## **City of Keene Planning Board**

### **AGENDA - AMENDED**

- a. **PB-2024-18 – Cottage Court Conditional Use Permit – 133 Roxbury St** - Applicant Unicron Management, on behalf of owner Mahantrashti Real Estate LLC, proposes the conversion of an illegal 7-unit building at 133 Roxbury St (TMP #569-099-000) into four units. The parcel is 0.25-ac in size and is located in the High Density District.

Figure 2. A snippet of the proposed conditions plan for 133 Roxbury St.

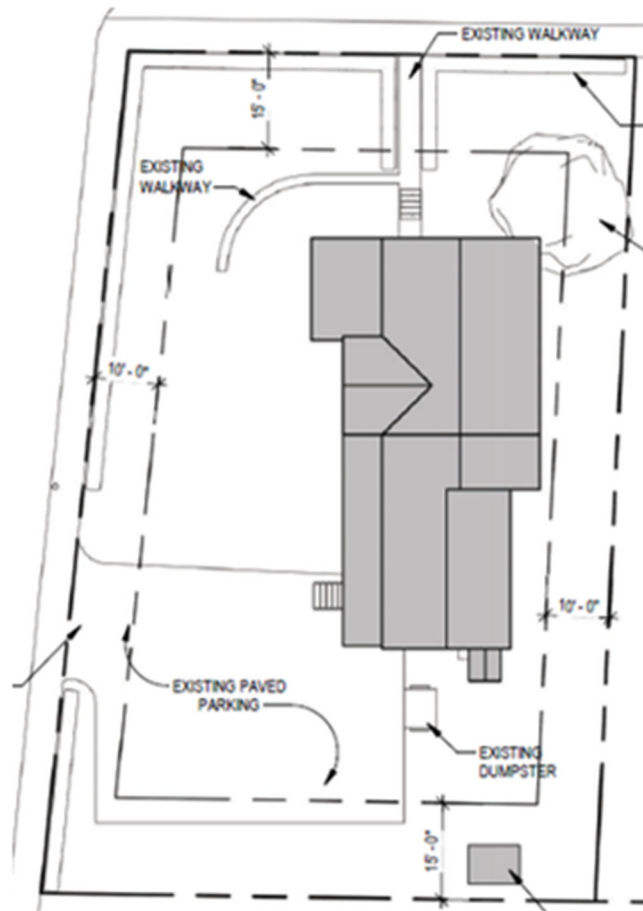
- The existing driveway is in poor condition and has a ponding low point area adjacent to the City's existing sidewalk; it is recommended that the driveway at the interface with the City's sidewalk be reclaimed, re-graded and repaved to provide positive pitch to eliminate the ponding adjacent to the City's sidewalk and road infrastructure.
- The width of the existing driveway with parking on either side appears insufficiently wide for cars to turn around in the driveway and requires them to back out into the road. Given this, the existing bushes along the property frontage on both Harrison Street and Roxbury Street are recommended to be cut back to minimize the current line of sight obstructions and eliminate the obstruction of the City's sidewalk.

This property is located in the floodway, and the applicant may need a Floodplain Development Permit to make grading changes as suggested by Engineering Staff.

In response to the City Engineer's comments, the applicant stated that the existing parking area would be regraded and repaved to provide a positive pitch to eliminate ponding adjacent to the City's sidewalk and road infrastructure. An updated proposed conditions plan with a note stating that the parking area would be repaved and regraded was submitted as part of the revised application materials.

2 PROPOSED ARCHITECTURAL SITE PLAN  
 3/32" = 1'-0"

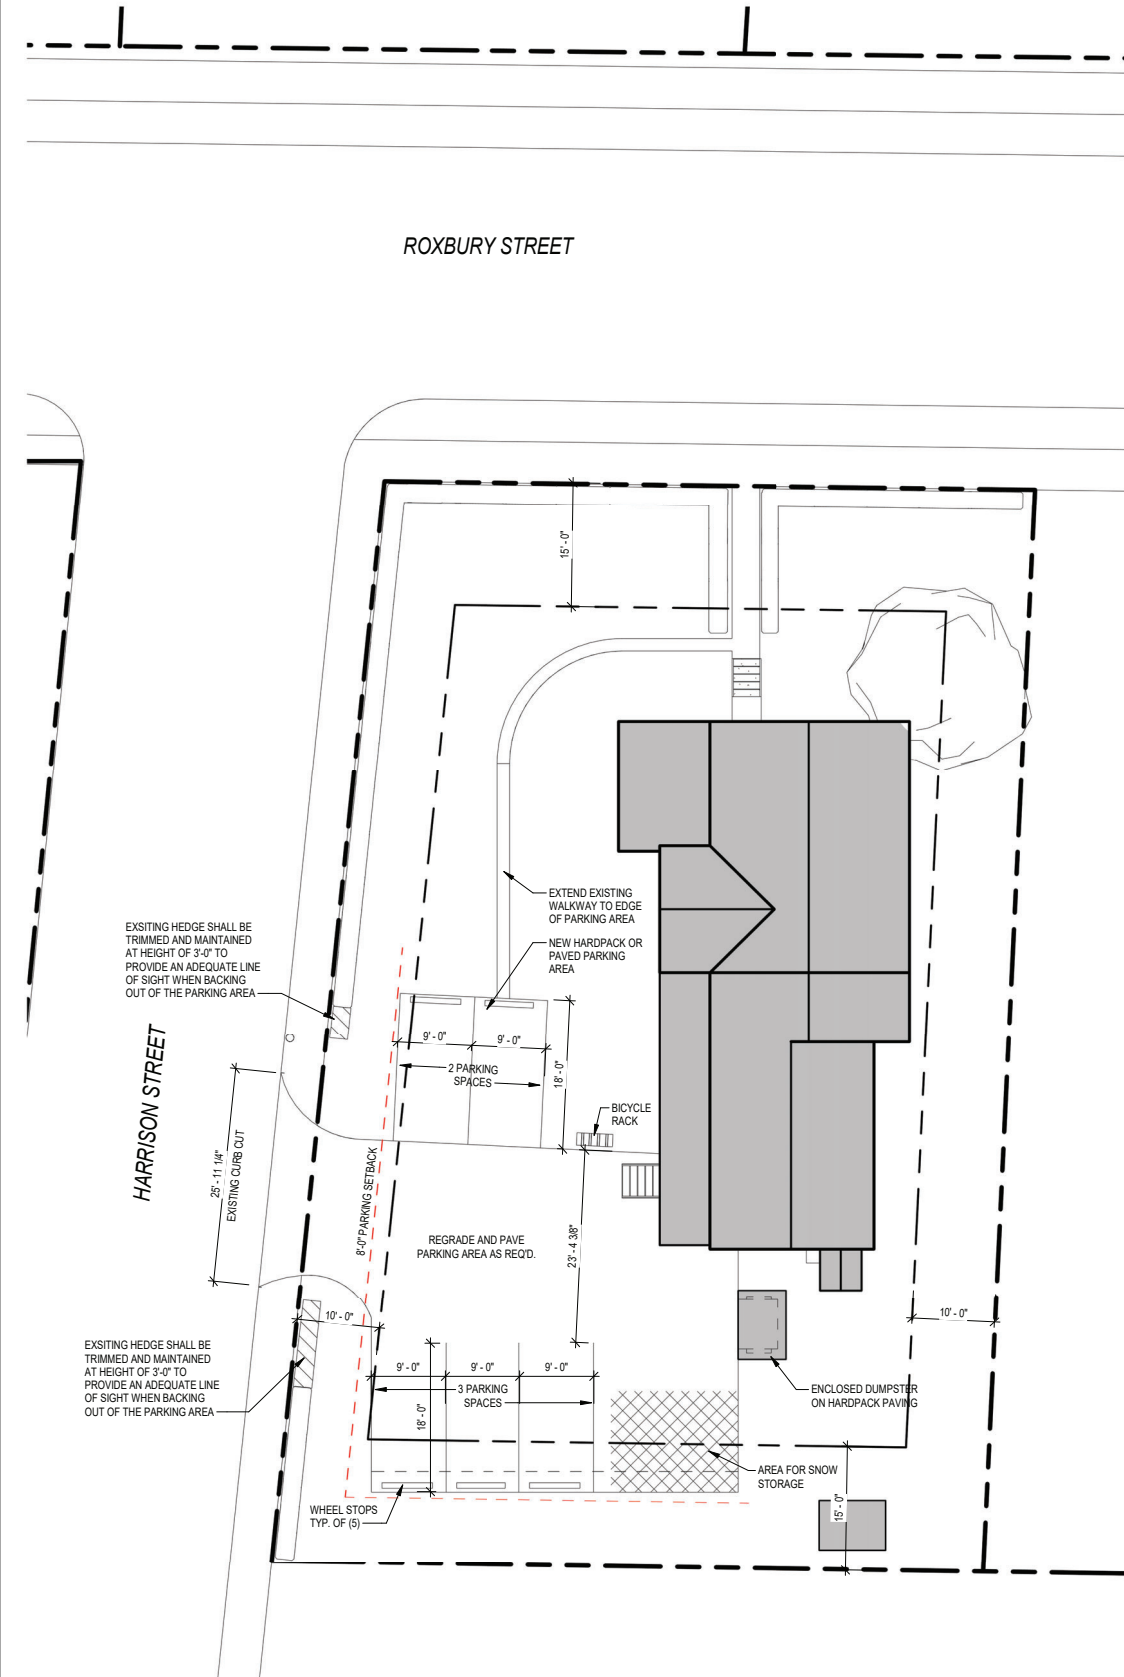
located in the existing parking area to the southwest of the building. The parking area will be expanded to add two spaces along the northern edge and all parking spaces will be screened from view of Harrison St by the existing hedge, which will be trimmed to a lower height to maintain safe sight distances for vehicles entering and exiting the parking lot. This standard appears to be met.

The existing and proposed plans also show an existing fence along the southern and eastern property boundaries, which may actually be located on the adjacent parcels at 16 Harrison St and 139 Roxbury St. Planning Staff recommend that the Board include a recommended condition of approval to require the submittal of an updated proposed conditions plan showing the appropriate property line and fence locations prior to the issuance of final approval for the project.

- c. Submittal of an updated proposed conditions plan showing the accurate locations of the fence and property lines.*
  - d. Submittal of existing and proposed grading & drainage plans prepared by an engineer licensed in the State of NH subject to review and approval by the City Engineer's Office.*
- 2. Subsequent to final approval and signature by the Planning Board Chair, the following condition shall be met:**
- a. Prior to the commencement of parking lot modifications, the submittal of an approved Floodplain Development Permit, if deemed necessary by the Floodplain Manager."*
